Consider Request for Sketch Plan Review and Site Plan Review of Stoney River at 14501 Nowthen Boulevard

**Re: Sketch Plan (Minor Plat) and Site Plan Review
Stoney River**

**CITY OF RAMSEY PLANNING DIVISION
REVIEW FILE**

DATE	6/30/2011	PROJECT ADDRESS	TBD
PROJECT TITLE	STONEY RIVER ASSISTED LIVING AND MEMORY CARE		
REVIEW FILE #			
APPLICANT:	First Phoenix Group		
PRIMARY REVIEWER:	Tim Gladhill– Senior Planner Phone: 763-576-4308 Fax: 763-433-9848 e-mail: tgladhill@ci.ramsey.mn.us

**OVERALL
 SITE PLAN
 C2.0**

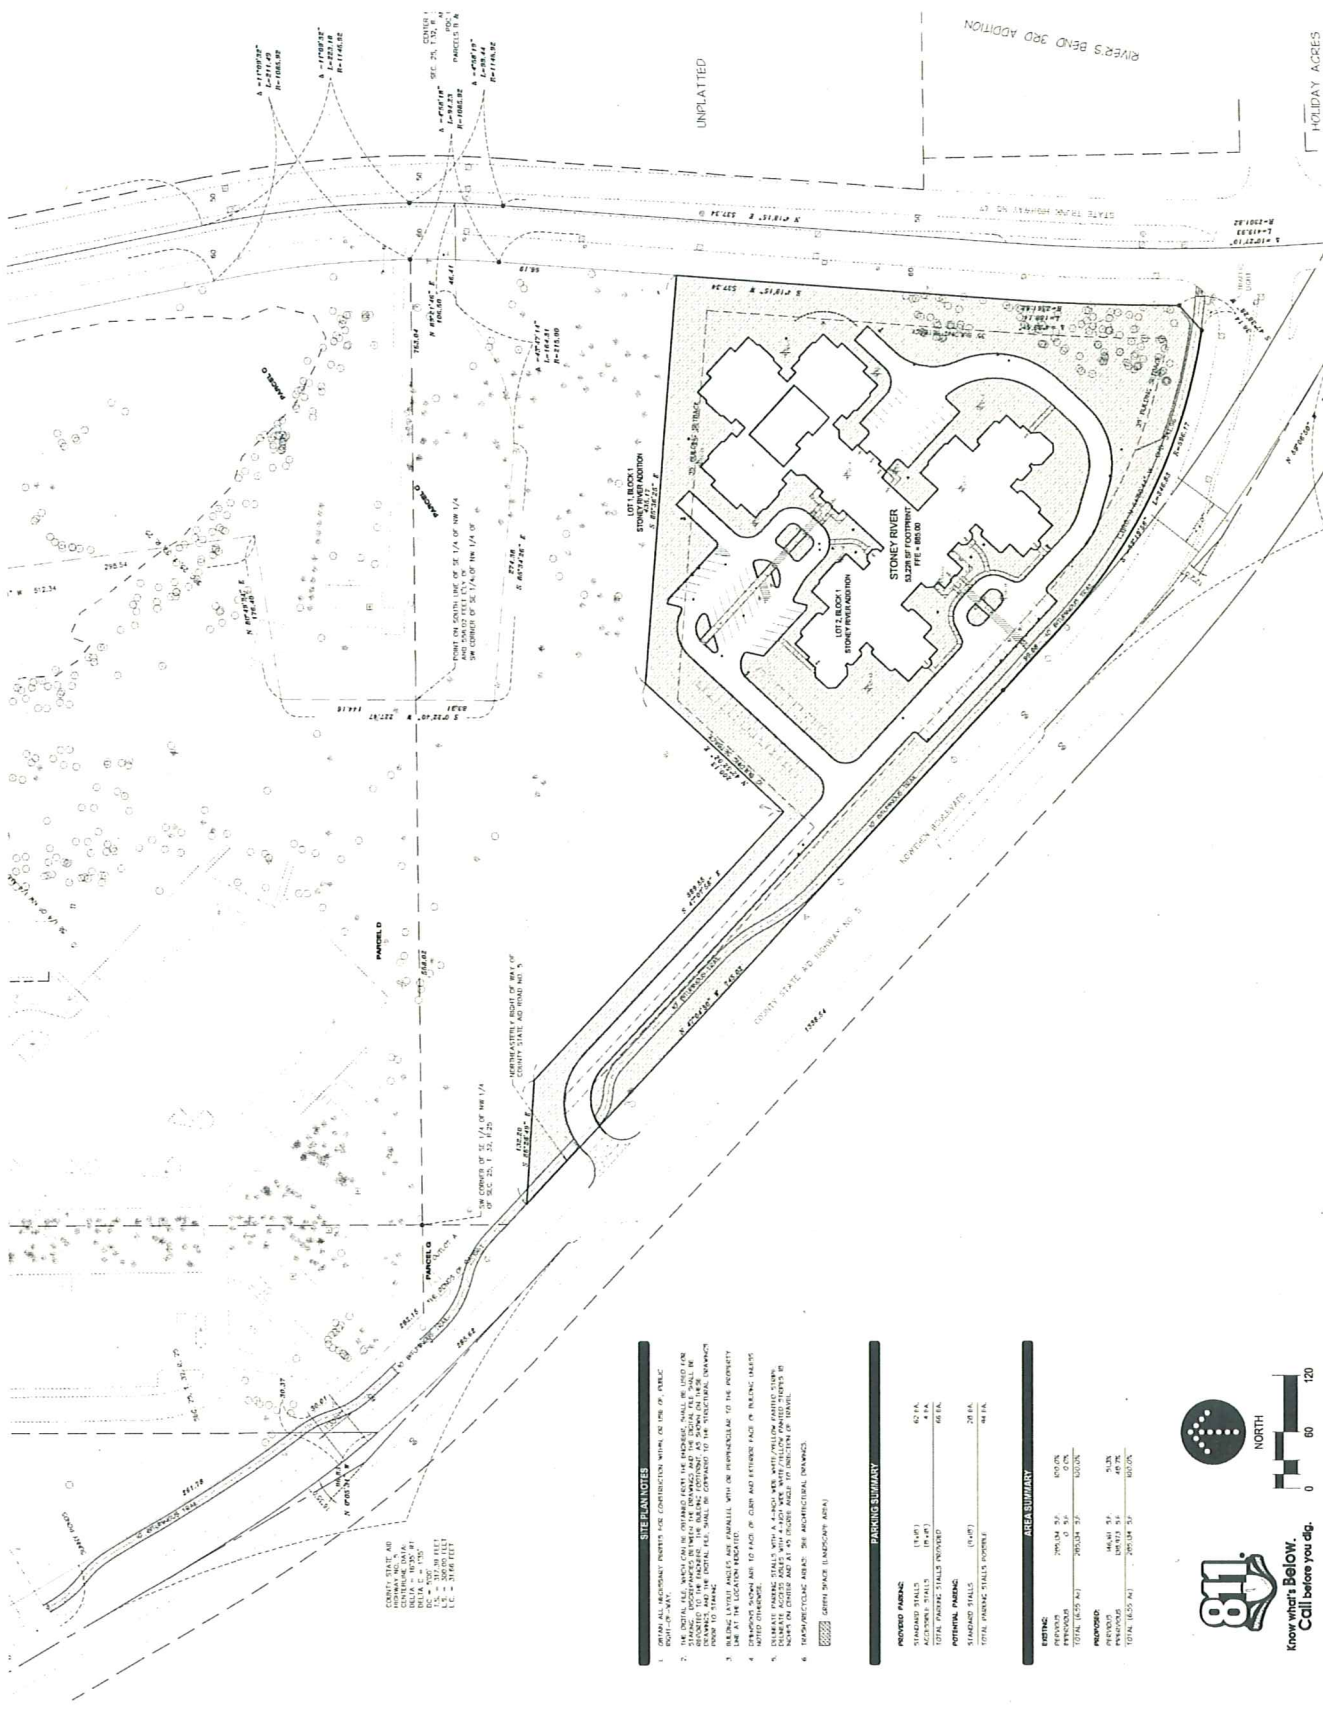
It appears that a majority of the required setbacks are met with the proposed site plan. However, the required setback for parking and maneuvering areas when abutting residential areas is deficient. Given the tight spacing in the rear of the proposed lot, Staff encourages amending the rear property line to increase the size of the proposed lot, thus increasing the amount of green space provided to the proposed assisted living/memory care facility. This could be done for all, or a small portion of the rear property line. The fire access land is exempt from this setback. Alternatively, the Applicant could request that a variance be processed to account for the deficiency.

Off-Street Parking - Spaces Required: The B-1 District sets a minimum parking space standard of one (1) space per four (4) hospital beds plus an additional space for each employee. The site plan proposed 66 off-street parking spaces with space for an additional 28 spaces. It appears that there is ample parking for this type of use. Please provide the City with the number of employees for final verification of parking requirements.

5 B612 CONCRETE CURB AND GUTTER
 NO SCALE

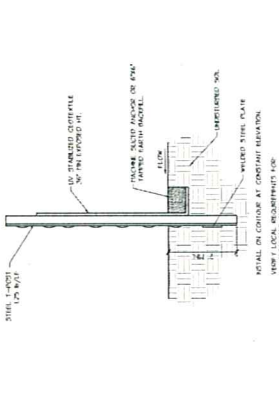
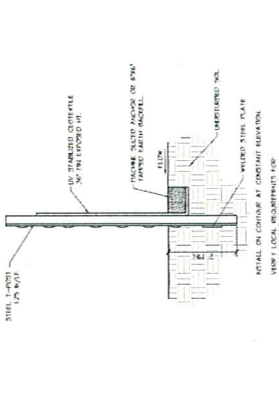
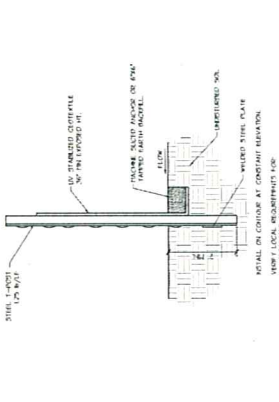
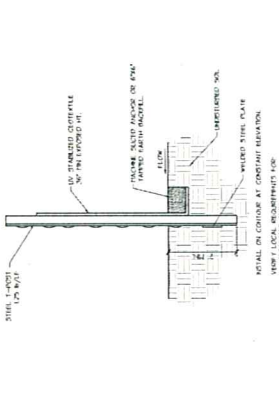
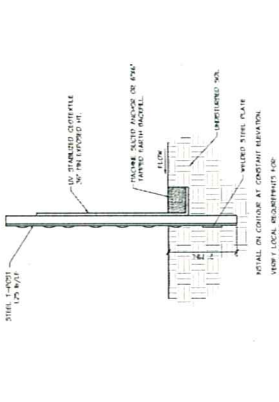
- Please make sure that all items shown on the various plan sheets are either clearly noted on the plans or are referenced in the legend.
- The B612 concrete curb detail should be amended to include base material extending to 1' beyond the back of curb. There are other City standard details that should also be included, and we can forward those to you for incorporation into the plans.

- The pedestrian ramp details have recently been modified at the state level, and the plans should be revised to include the most recent Mn/DOT approved detail and design.

SHEET NUMBER
 L2.1

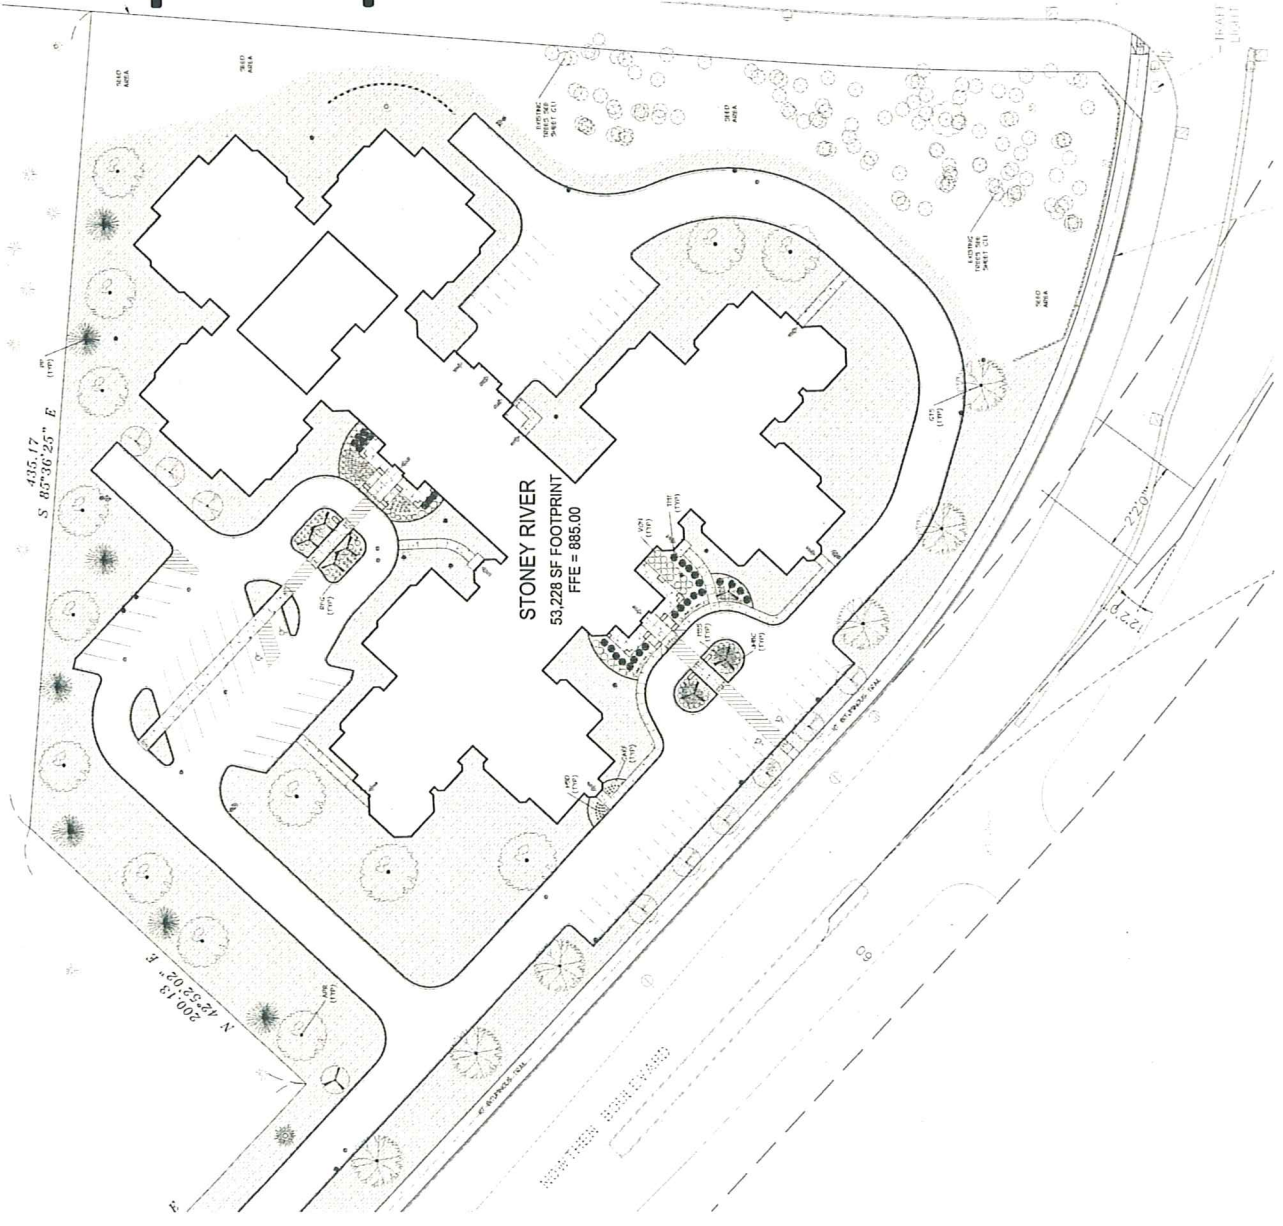
- Tree save fencing must be identified on both the grading plan (sheet C3.1) and the landscaping plan (sheet L2.1) and must be installed prior to any land disturbance activities.

- The following should be added to the notes section on sheets L2.1 and L2.2: Topsoil, whether imported or amending the existing topsoil, must meet or exceed Mn/DOT's Premium Topsoil specification (3877.3). The City has a list of 'pre-certified' suppliers that have submitted test results verifying the material meets this specification. If you opt to use an alternative supplier, or if amending onsite topsoil, documentation must be supplied to the City verifying that the material meets Mn/DOT's Premium Topsoil Borrow specification. A copy of the load tickets will also be required to pass the topsoil inspection.

- The Plans indicate various areas will be seeded rather than improved with sod. All areas not otherwise improved shall be finished with sod. Any deviation from this condition requires City Council approval.

- Any disturbed areas of right-of-way shall be restored to County and Mn/DOT standards, whichever may be applicable.
- Should City Council approve the use of seed rather than sod, details must be added to sheets L2.1 and L2.2 outlining application rate(s) and installation method.

- Please add labels to sheets L2.1 and L2.2 indicating which symbols represent Autumn Blaze Maple and Prairiefire Crabapple.
- Note #10 on sheets L2.1 and L2.2 references a McDonald's site, revise to state Stoney River.

- Add planting details for deciduous and coniferous trees and shrubs. The detail must, at a minimum, indicate the following:
 - Planting depth shall be such that the first set of primary roots is at final grade.

- Remove twine, wiring, ropes and burlap from top and sides of root ball.
 - At time of planting, only prune out dead or damaged branches. All necessary pruning cuts shall be made just outside of branch collar area.

- Remove all tags and labels.
 - Wood chip mulch shall not be piled against the trunk of trees.
- A two (2) year maintenance guarantee is required on all landscaping after initial acceptance by the City. Please add this to the notes section of sheets L2.1 and L2.2.
